March 28, 2014
Subject: **Augusta Phase 2**
State Project No: 020118.20
Amendment No. 2

Make the following change to the Bid Documents:

FOUNDATION PLAN - AREA-A PART PLAN

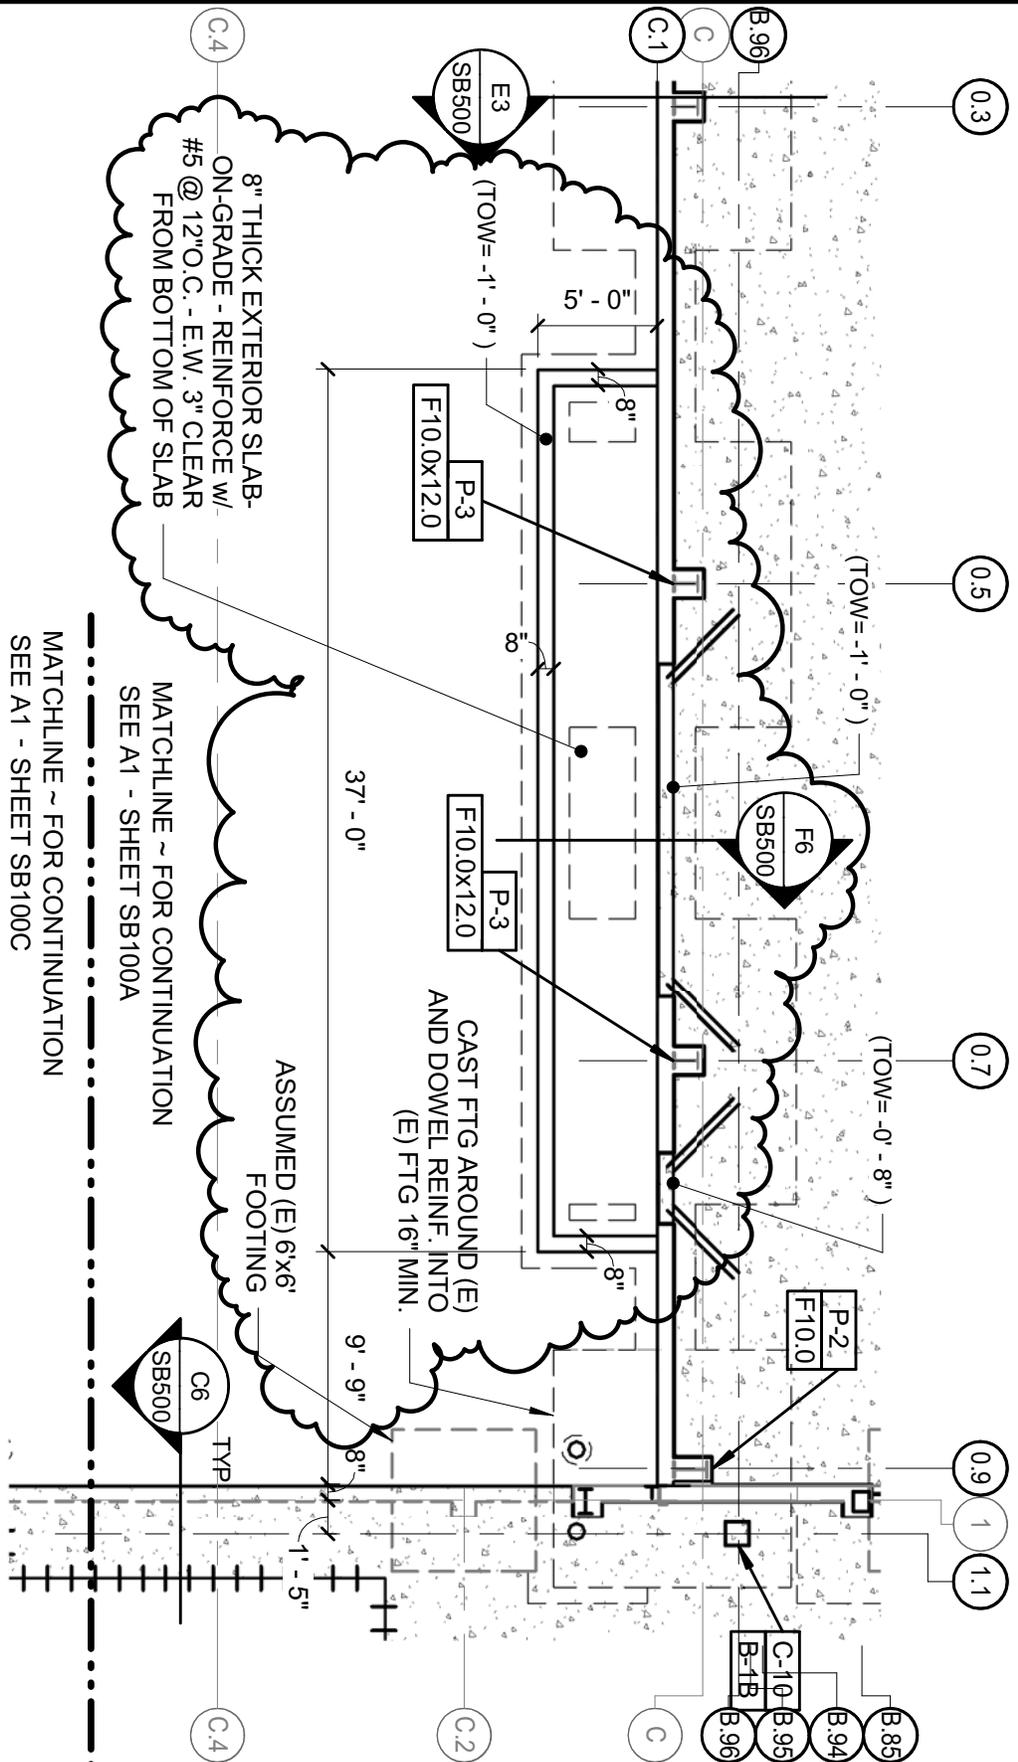
On plan Sheet SB 100A titled STRUCTURAL – FOUNDATION PLAN – AREA A, **REVISE** drawing per SKS-15.

DETAIL F6/SB500

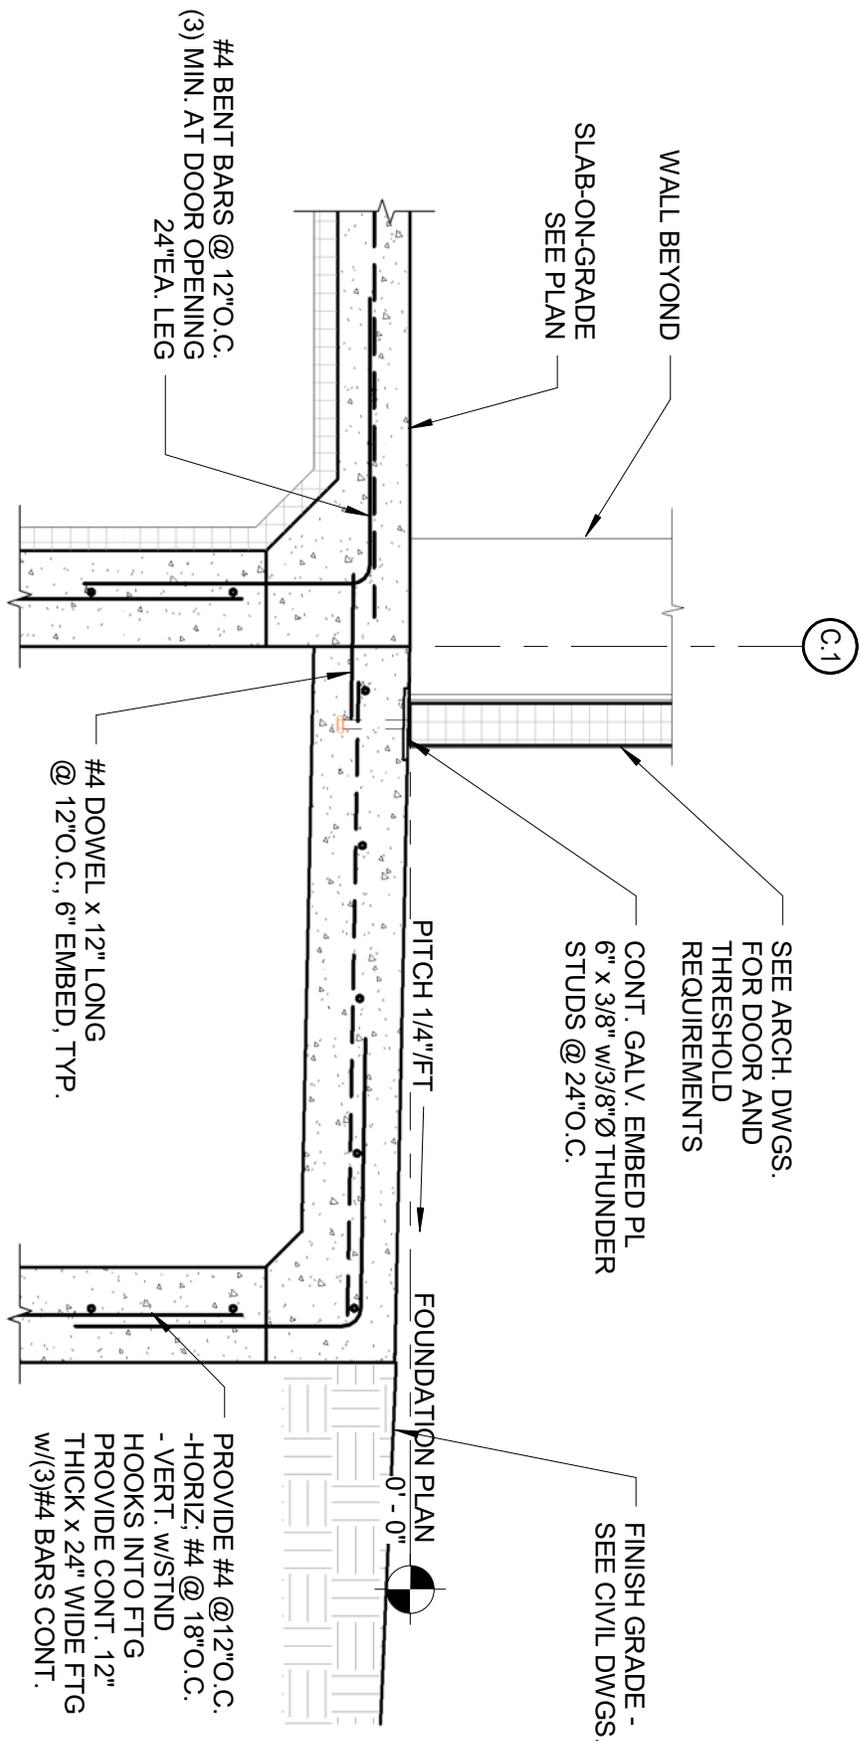
On plan Sheet SB 500 titled STRUCTURAL – FOUNDATION DETAILS, **DELETE** DETAIL F6 **ADD** in its place Detail F6 per SKS-16.

FOUNDATION PLAN - AREA-C PART PLAN

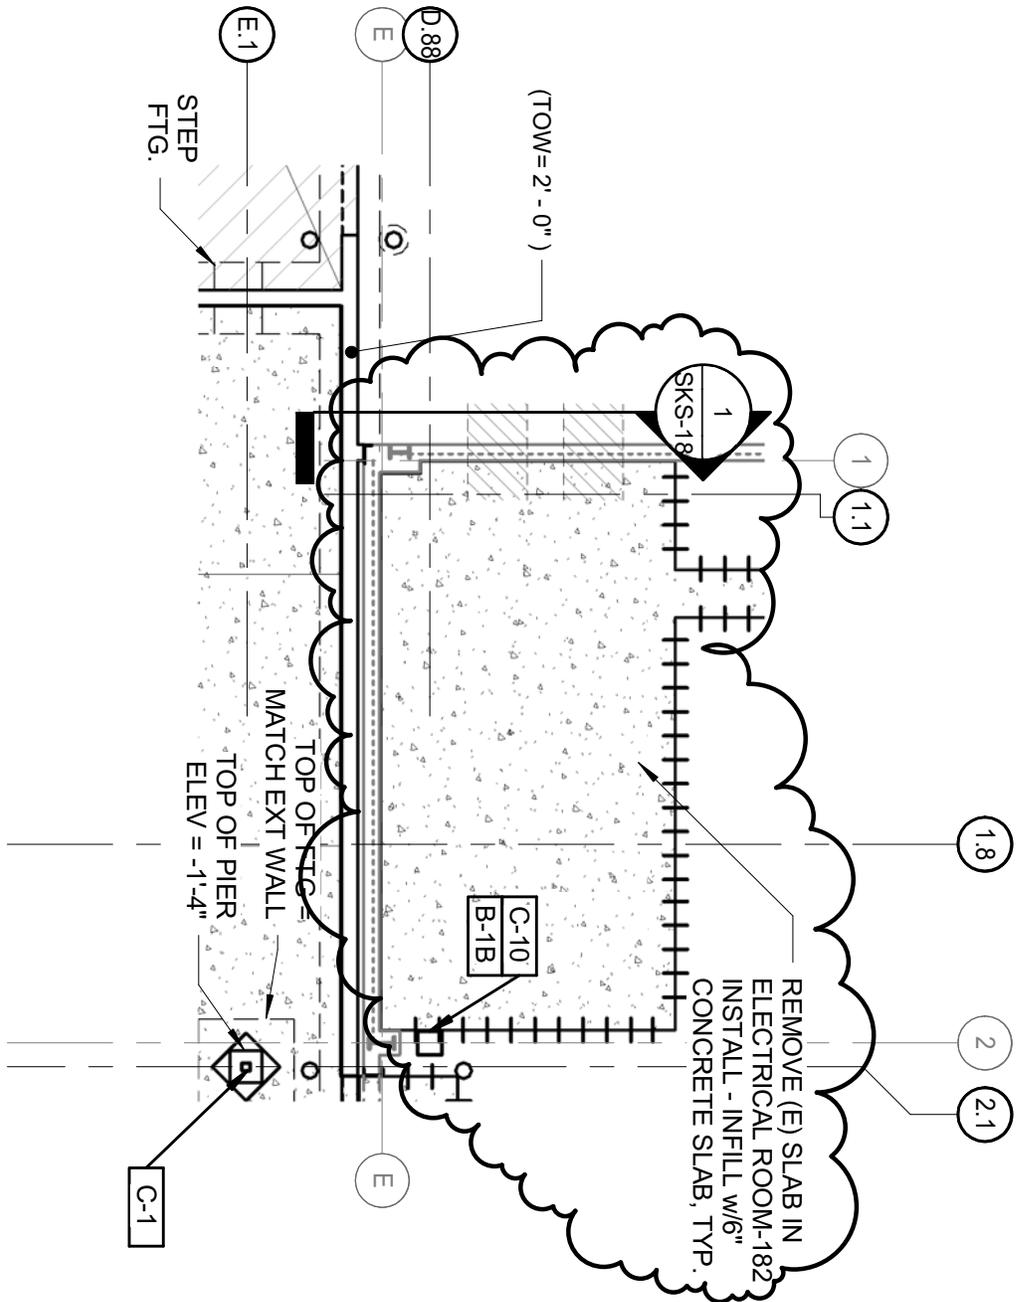
On plan sheet SD100 **REVISE** floor demolition per SKS-17.

On plan sheet SB100C **REVISE** floor demolition per SKS-17.

DETAIL-1 - REFER TO SKS-17

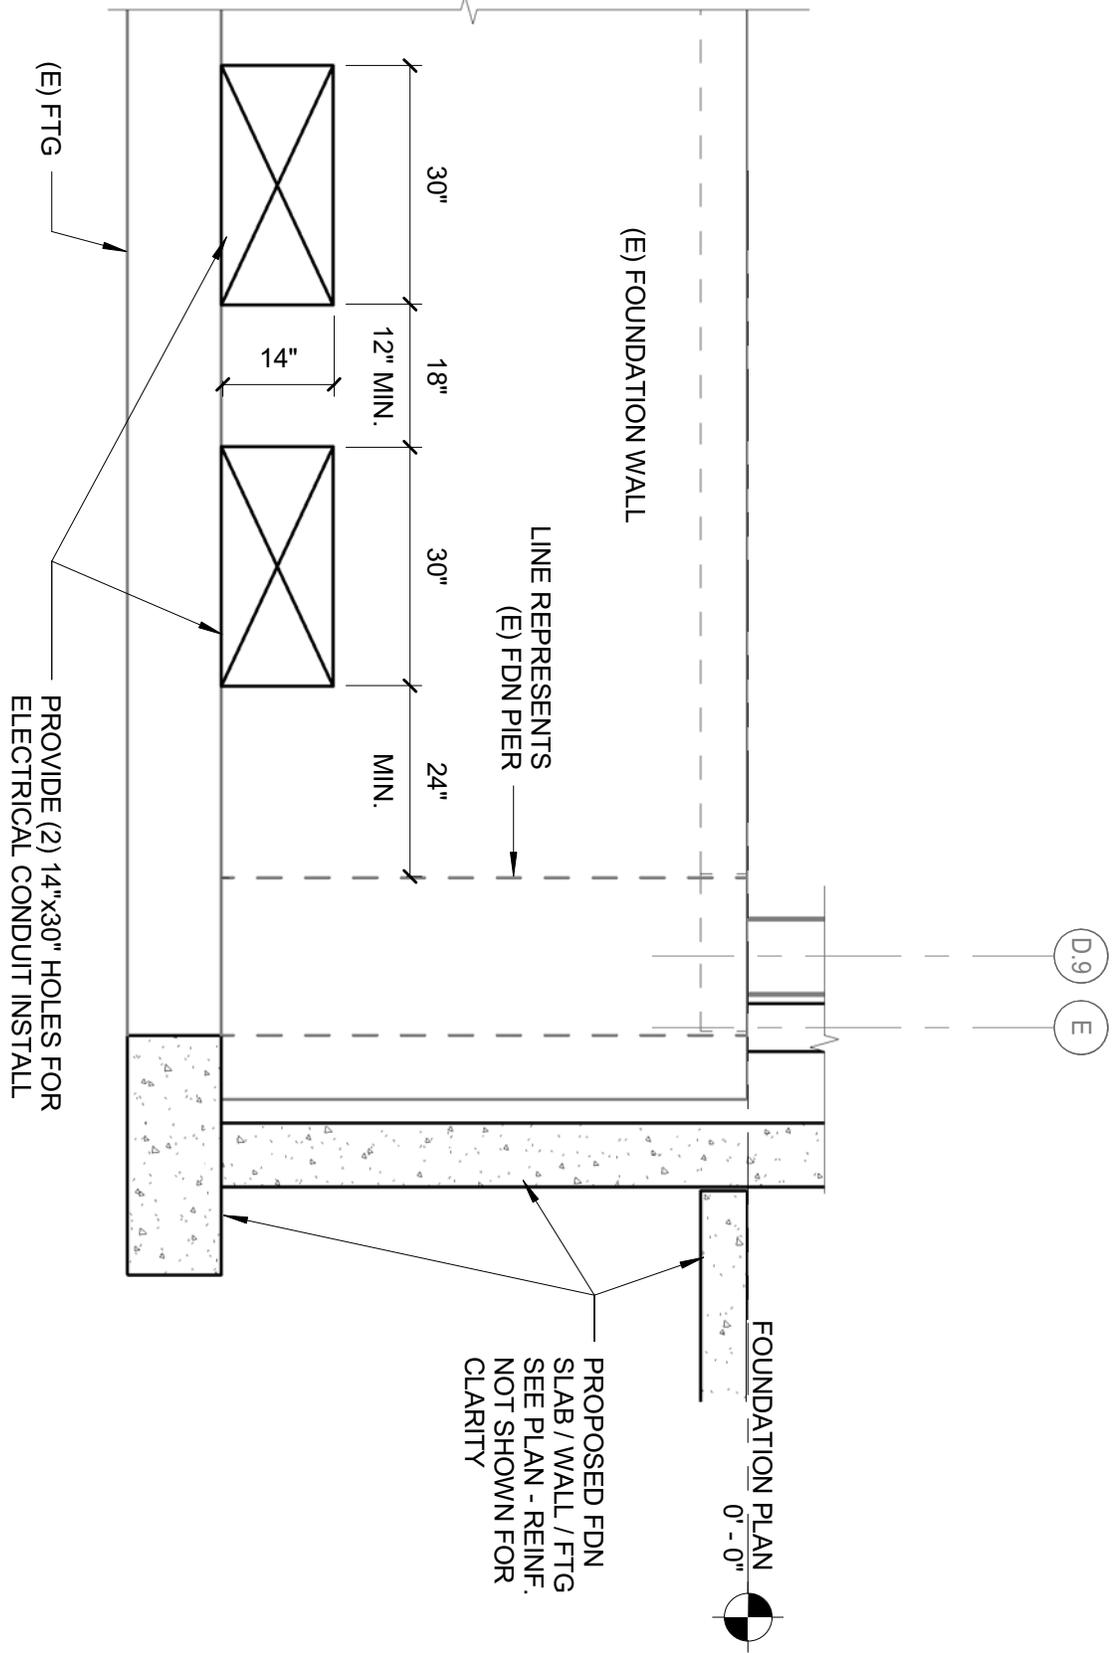
Add SKS 18 titled Detail 1 REFER TO SKS-17.

BUILDING SECTION - STRUCTURAL COORDINATION - SEE 6-A302

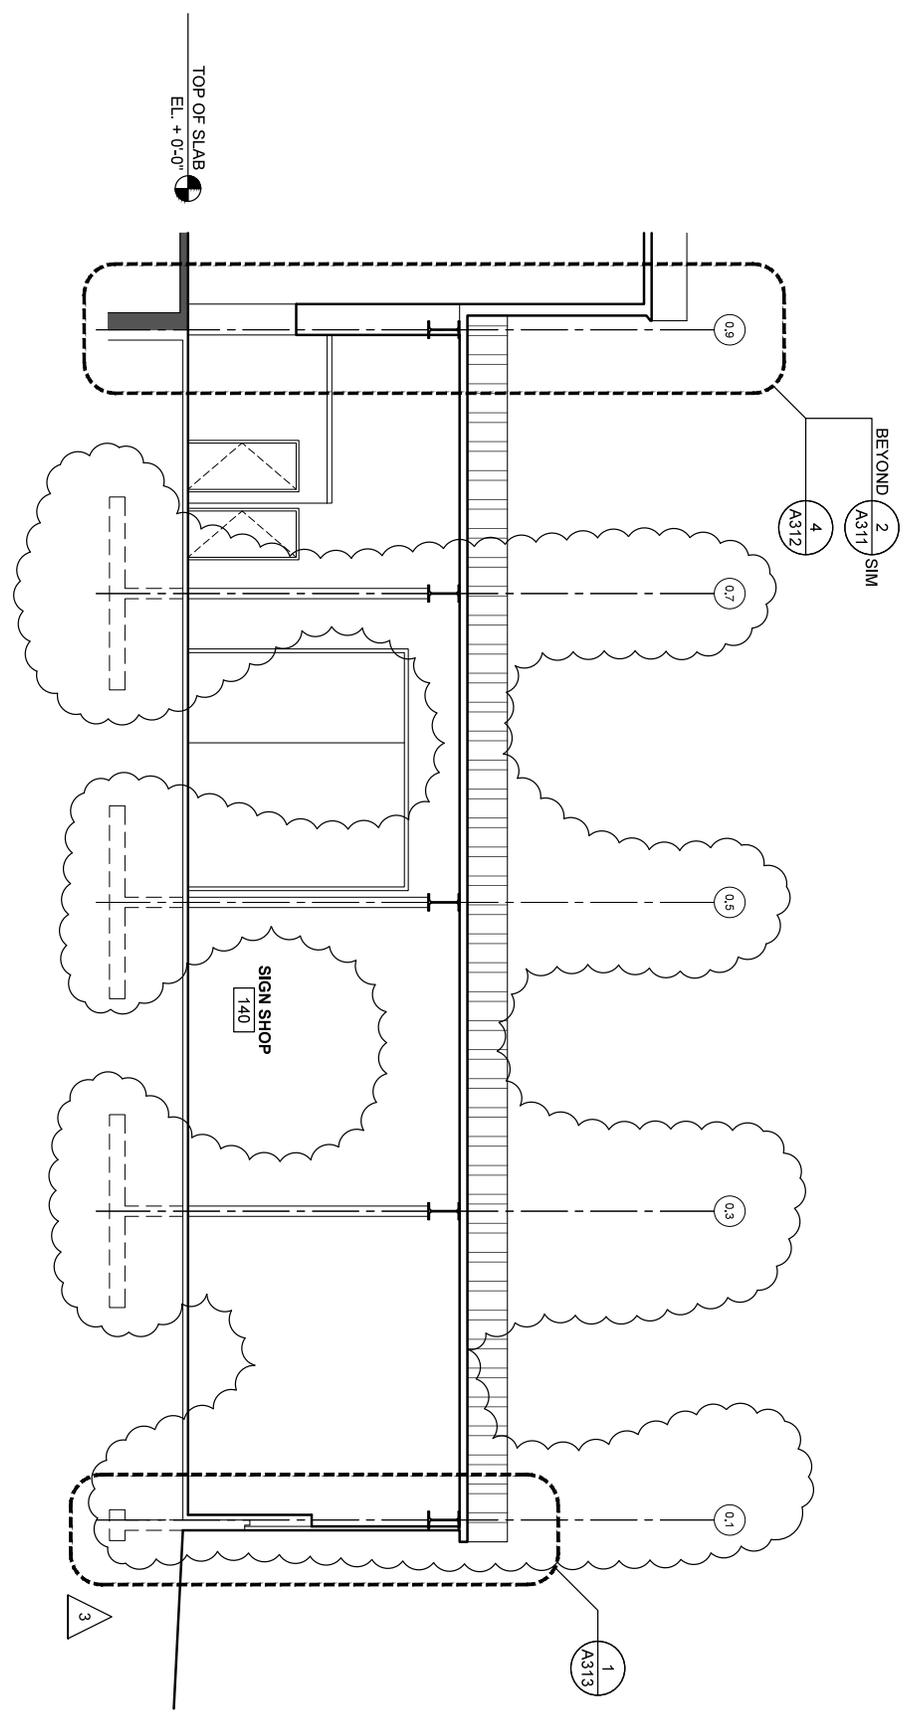
On plan sheet A302 **DELETE** Drawing 6 Building Section and **ADD** Drawing 6 Building Section per SKA-19 BUILDING SECTION- STRUCTURAL COORDINATION in its place.

BUILDING SECTION - STRUCTURAL COORDINATION - SEE 7-A302

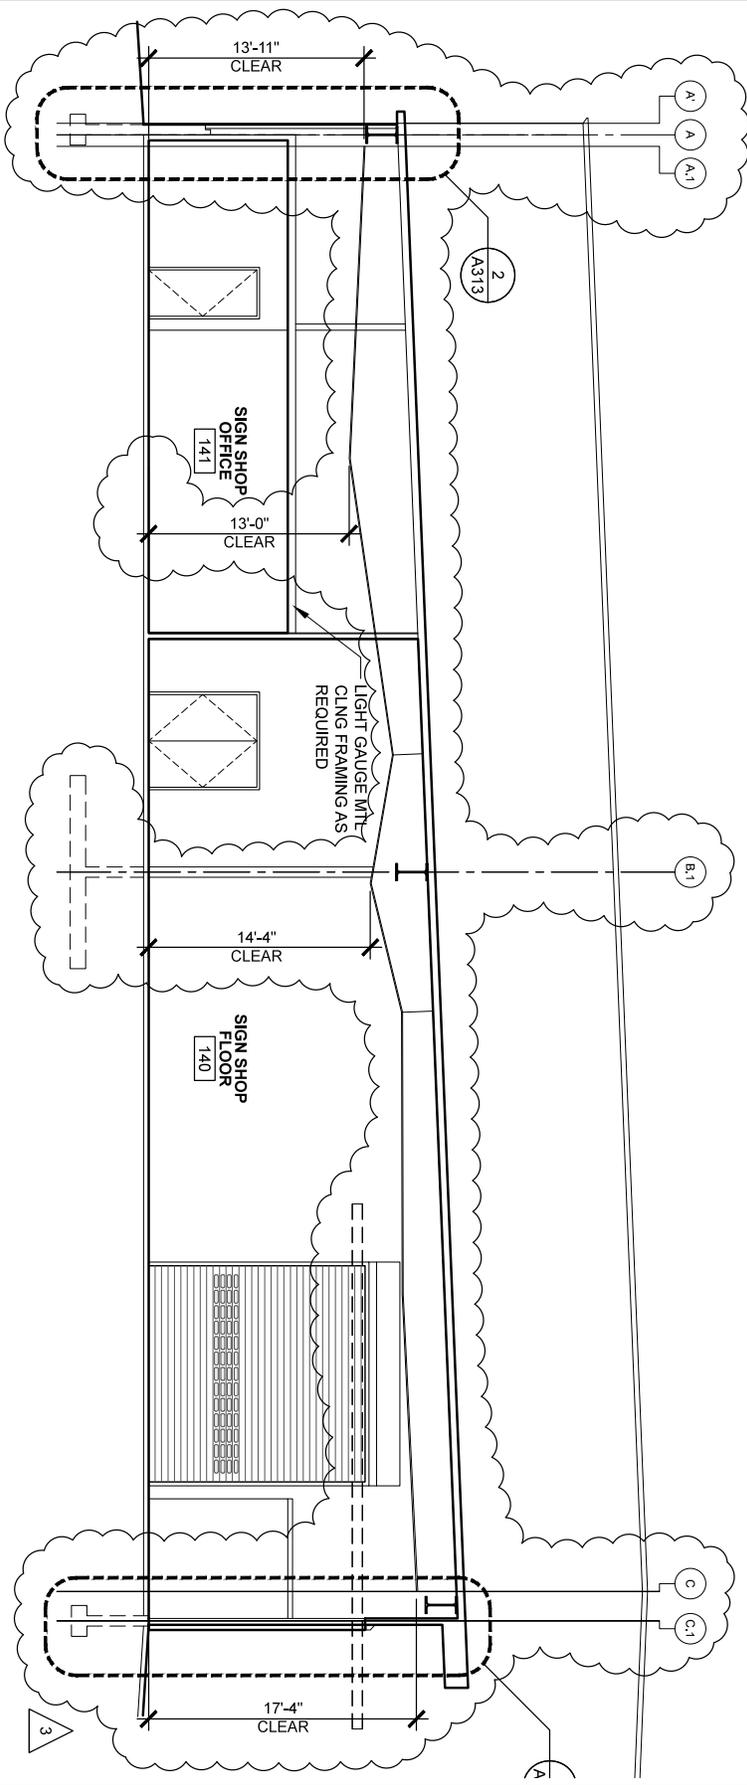
On plan sheet A302 **DELETE** Drawing 7 Building Section and **ADD** Drawing 7 Building Section per SKA-20 BUILDING SECTION- STRUCTURAL COORDINATION in its place.

WALL SECTION - STRUCTURAL COORDINATION - SEE 1-A312	
SKA-21 AMENDMENT #3	66 INDUSTRIAL DRIVE-PHASE 2 66 INDUSTRIAL DRIVE, AUGUSTA, MAINE MAINE DEPARTMENT OF TRANSPORTATION
SCALE: AS NOTED	DATE: 03/28/14 PROJ NO: 13057 CAD FILE: A311.DWG

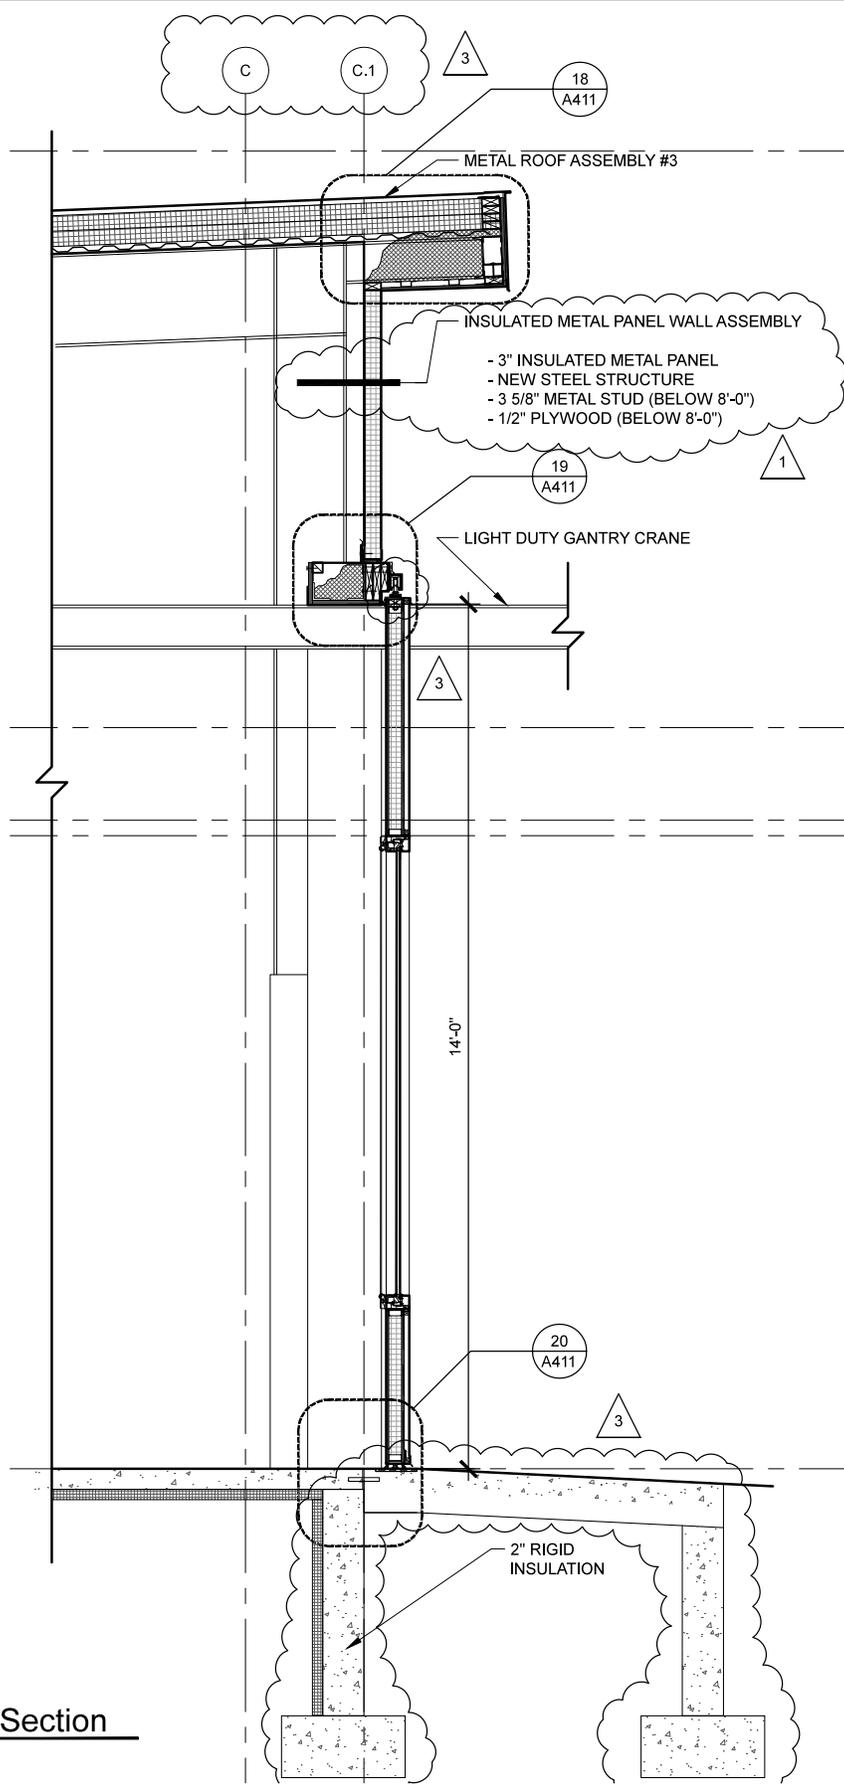
On plan sheet A312 **DELETE** Drawing 1 Sign Shop Wall Section and **ADD** Drawing 1 Sign Shop Wall Section per SKA-21 WALL SECTION- STRUCTURAL COORDINATION in its place.
